Planning Commission
Council Chambers
May 17, 2022 – 6:00 p.m.
233 South Main Street, Monroe, Ohio

Case No. 2022-5-4. Consideration of Site Plan Application for Four Seasons Car Wash

Case No. 2022-5-5. Consideration of Site Plan Application for Gateway Tire

DATE: May 17, 2022
RE: Information Packet for May 17, 2022 Planning Commission Meeting at 6:00 p.m.

SHEET:
L-1

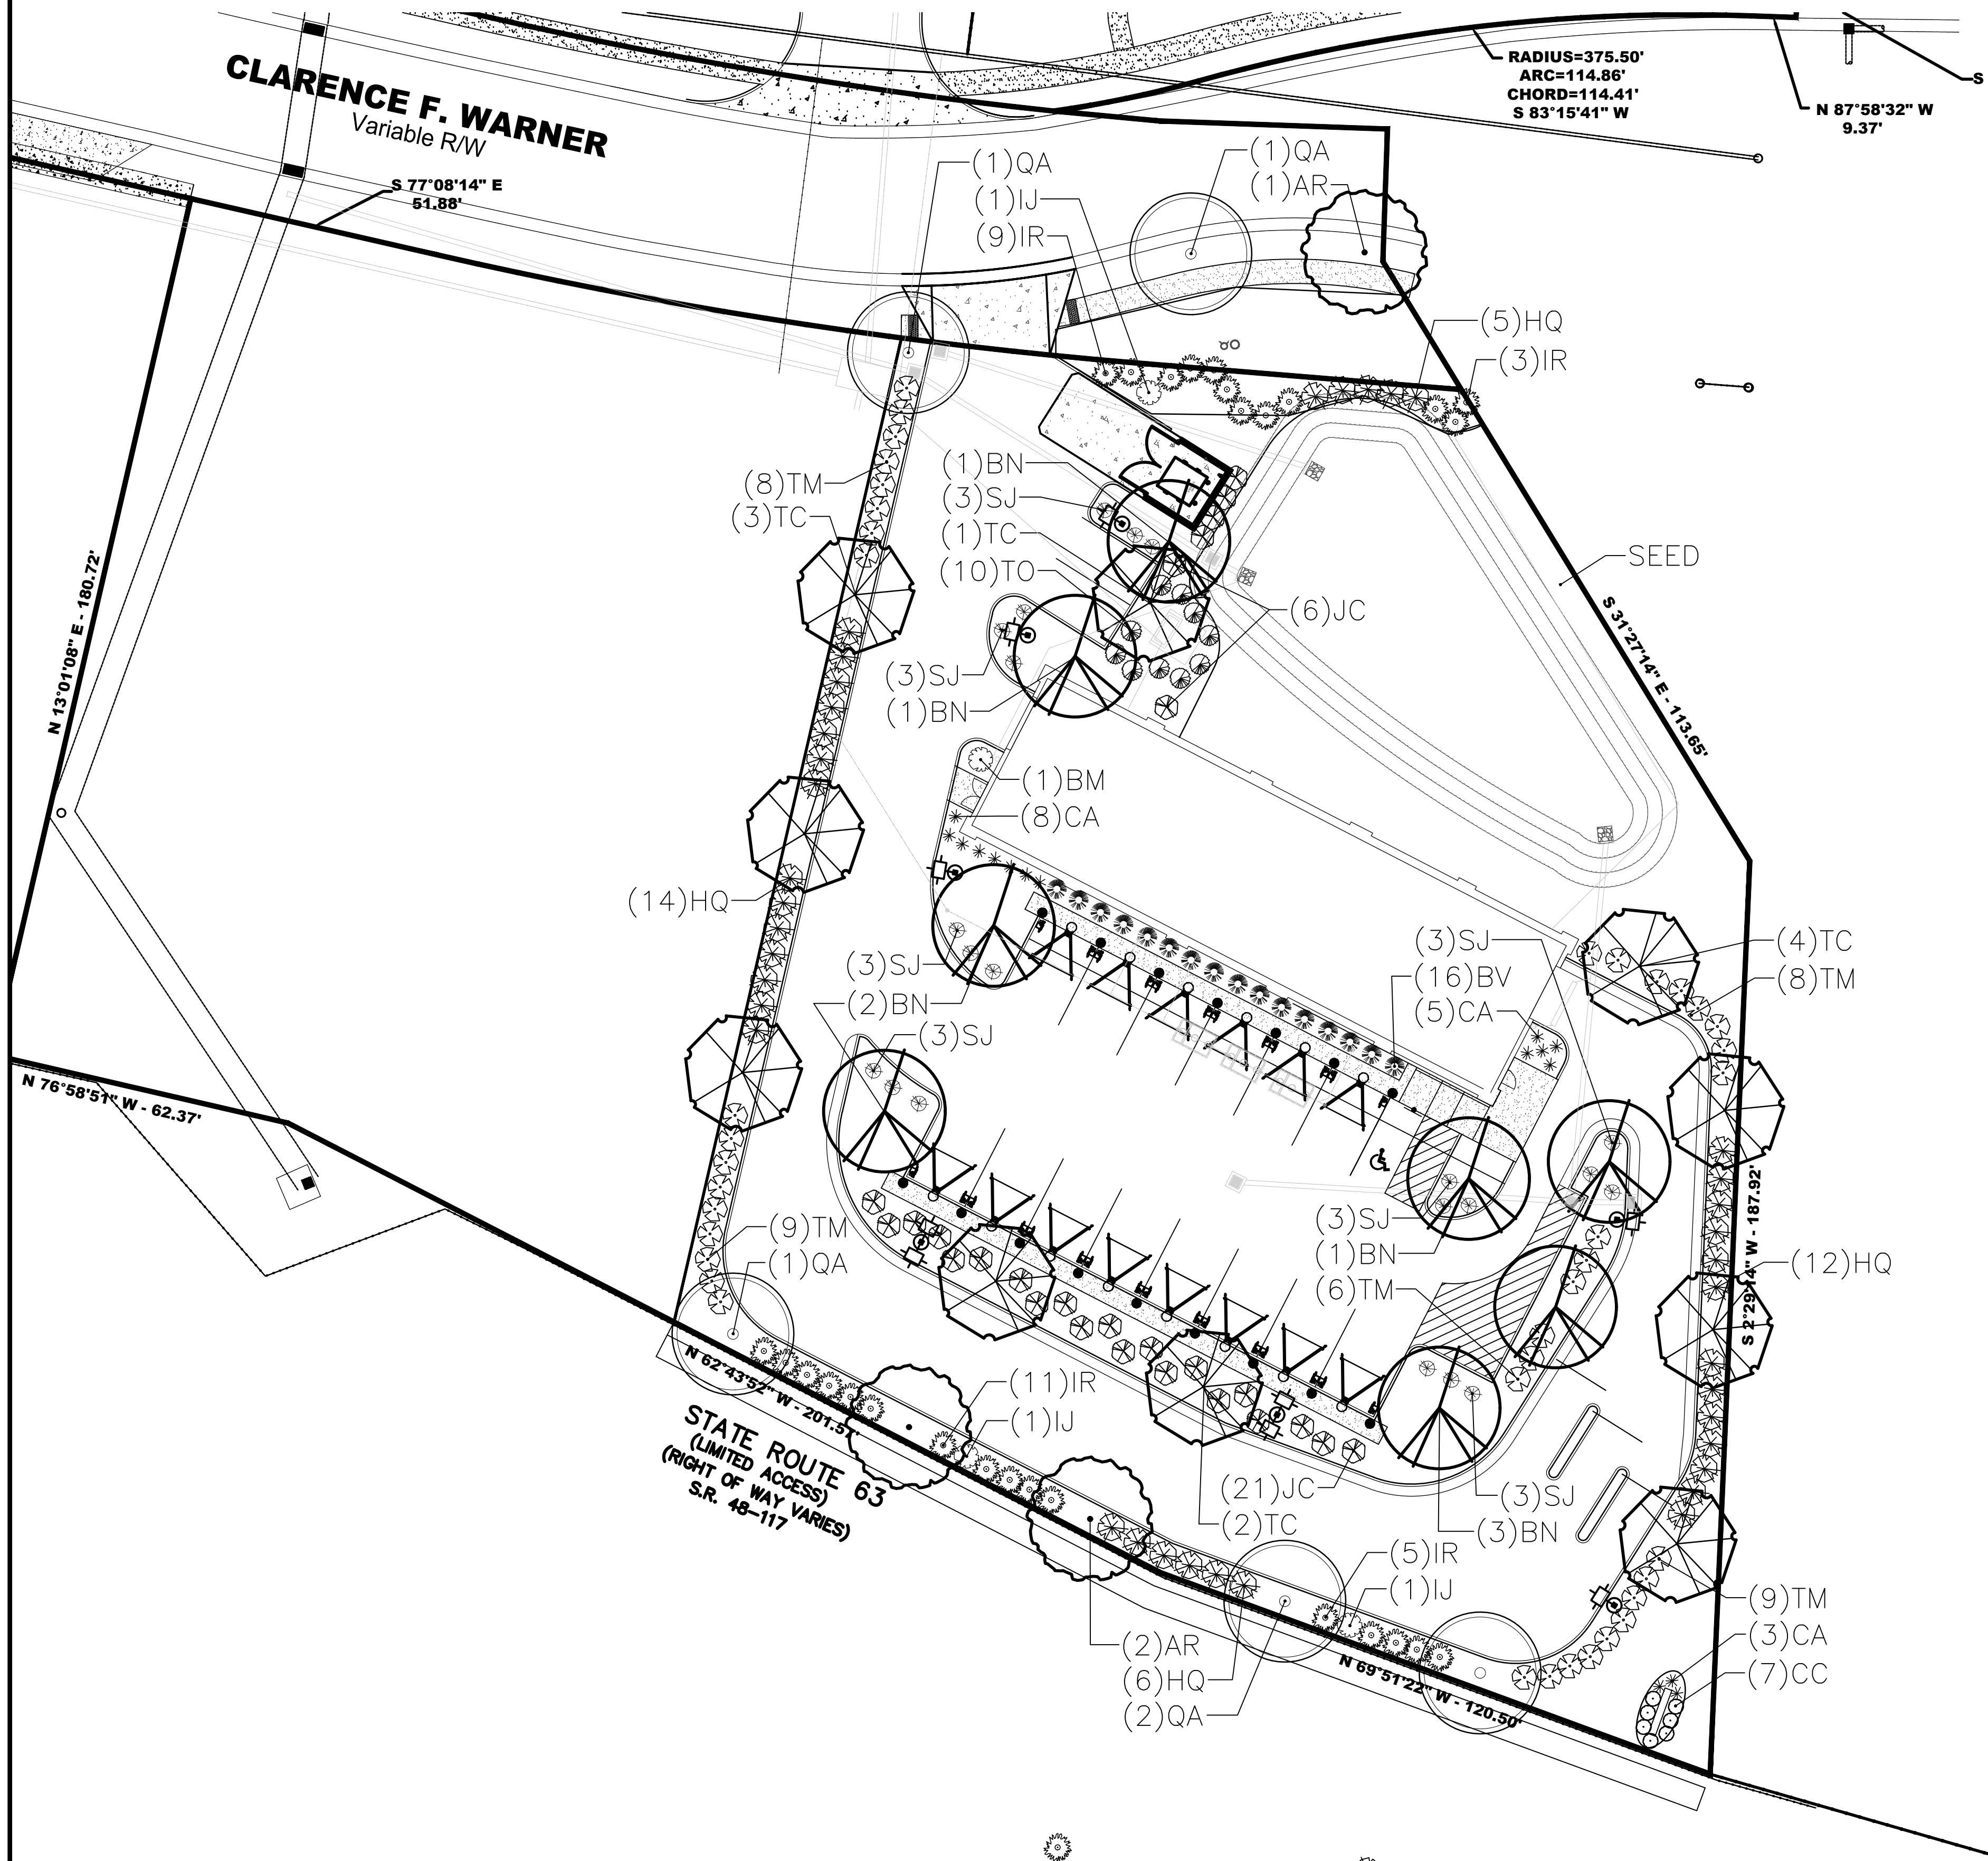
- **Landscaping–**
 - Street trees shall be required every 40 foot on center at all new sites along all private and public streets located 40' on center.
 - This requirement has not been met on State Route 63 where the length is approximately 230 FT, requiring 5 trees. Perimeter landscape trees cannot count towards meeting the street tree requirement along SR 63. Please revise.
 - The access drive landscaping quantities and the physical plants do not match on the landscape plan. Please revise to show the correct amounts.
- **Screening–**
 - As a reminder, screening walls may not be constructed of unfinished concrete or cinder block.

- Discussion and decision on the street tree requirement along State Route 63.
 - The landscaping plan be revised to correct the quantities and physical planting on the plan.

1 PHOTOMETRIC PLAN
1/16" = 1'-0"

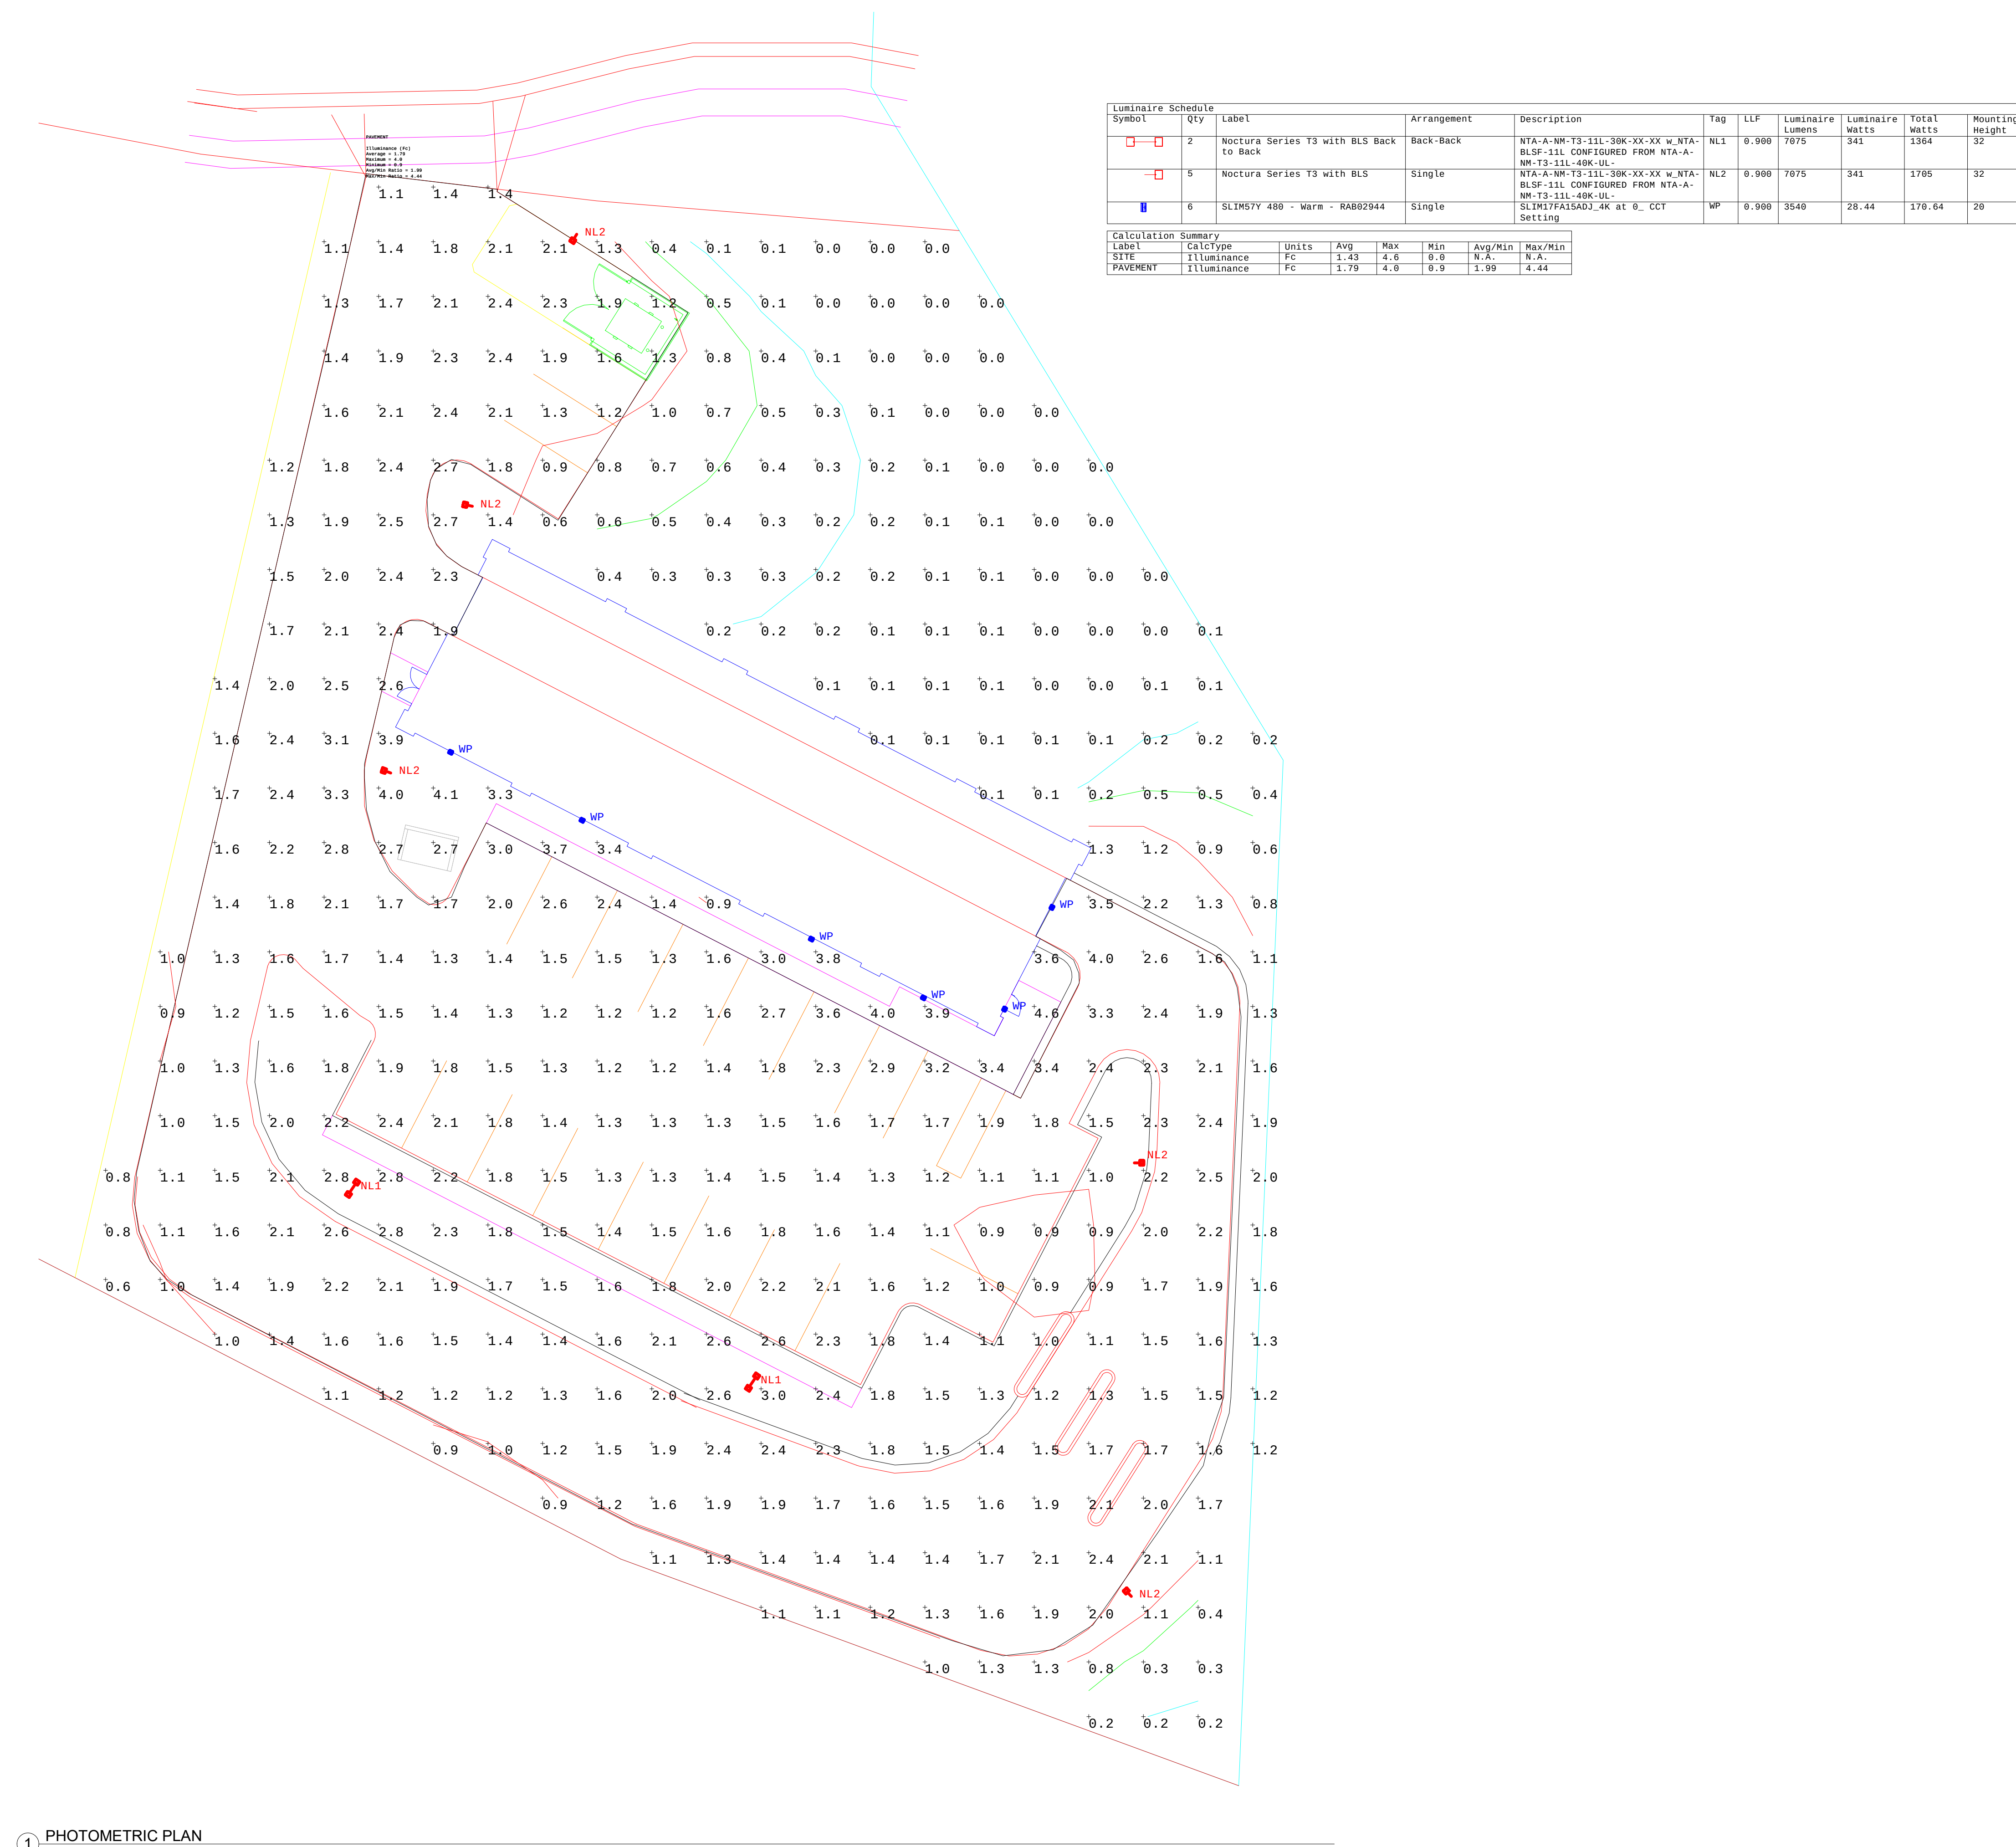
- **Photometric:**
 - The lighting plan submitted appears to show the site is under-lit in two small areas along the access drive and parking areas where the minimum required is 0.3 fc. Please revise.
